1 Proposed baseline for D3.0:

2
3 **79.3.2.5 PD requested power value**

79.3.2.6e PSE maximum available power

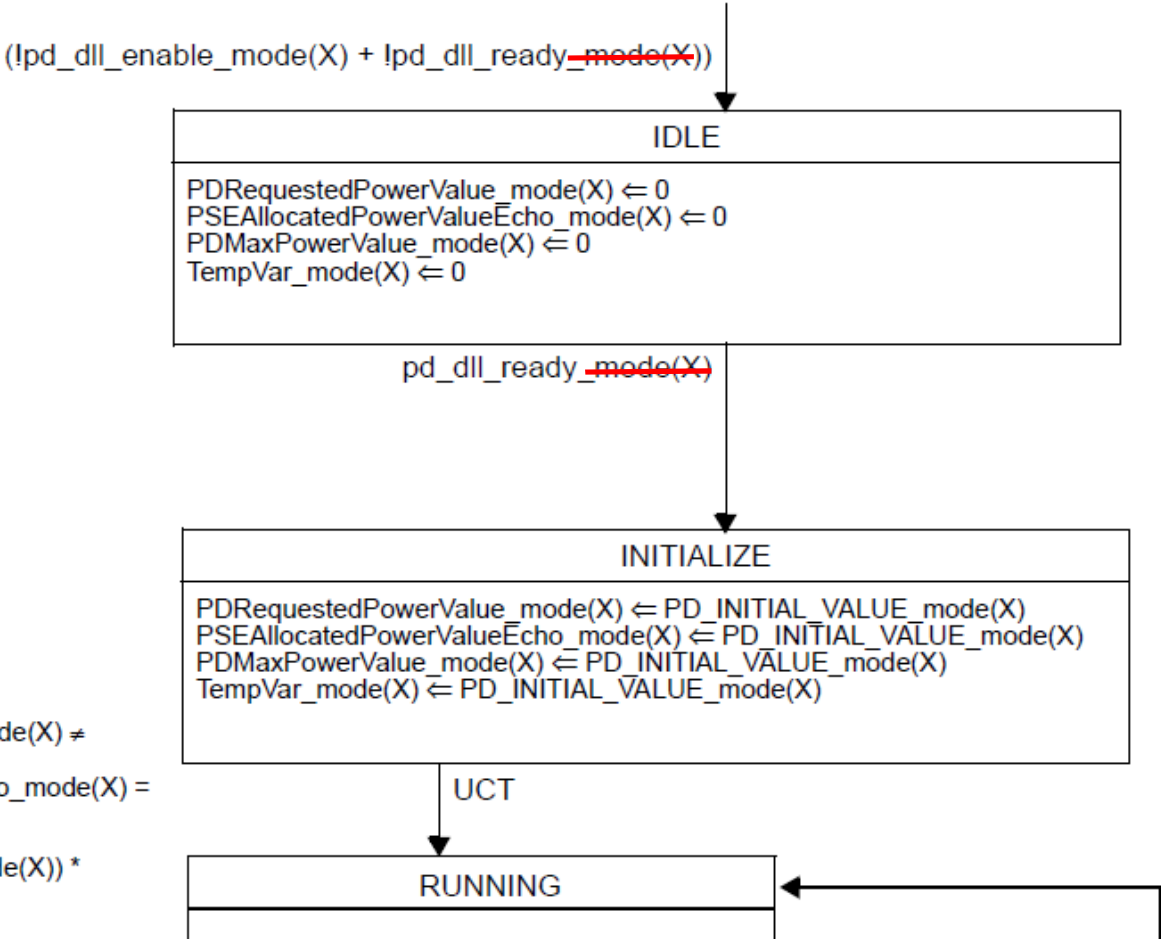
Not part of the baseline

Power management for single signature and dual signature cares only for the total port power. Parts of the power management then use this power to allocate it per A and B fields. The following changes will allow us to get rid of the requirement of $Y=A+B$ in D3.0 and set $Y=0$ instead, when Type 3 /4 PSE operating over 4-pairs is connected to dual signature.

1 The PSE maximum available power field shall contain the highest power the PSE can grant as defined in Table 79–6e [to the](#)
 2 [port when supporting single-signature PD or dual-signature PD PD](#). The PSE shall set the value of this field taking available
 3 power budget and hardware capabilities into account.
